Re: **The Aurora Highlands – Contextual Site Plan – Filing 1 (#1324907)/Pre-Application Meeting held October 11, 2018**

(RESUBMITTED FOR PRELIMINARY PLAT 06 – CSP 01 & 02 FLOODPLAIN LOTS)

PLANNING DEPARTMENT COMMENTS

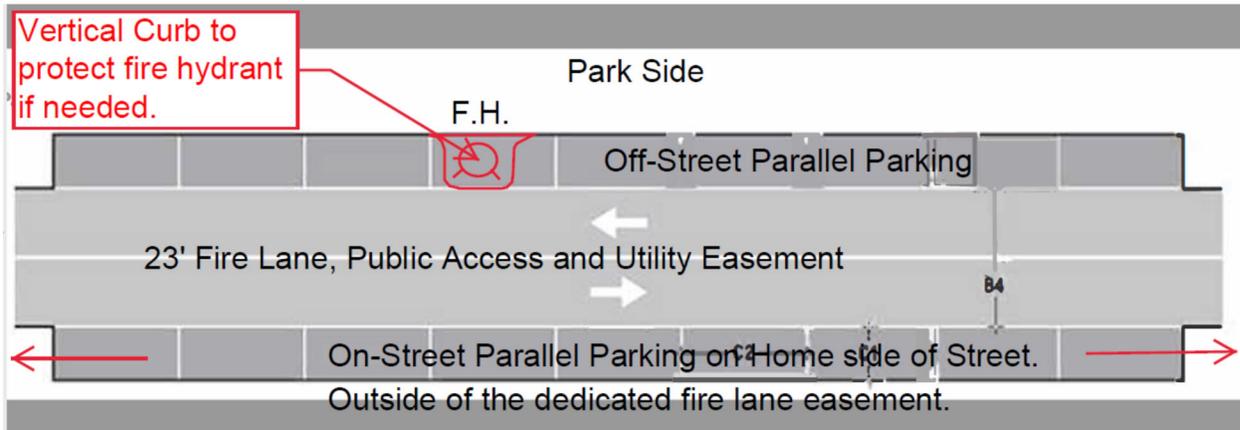
- The fire lane is typically located on the open space side allowing a 7-7 ½ foot parking area in front of each home. This parking area cannot encroach into the adjacent fire lane easement.

Response: Comment is not applicable to this application, roadways have been designed with previous filings.
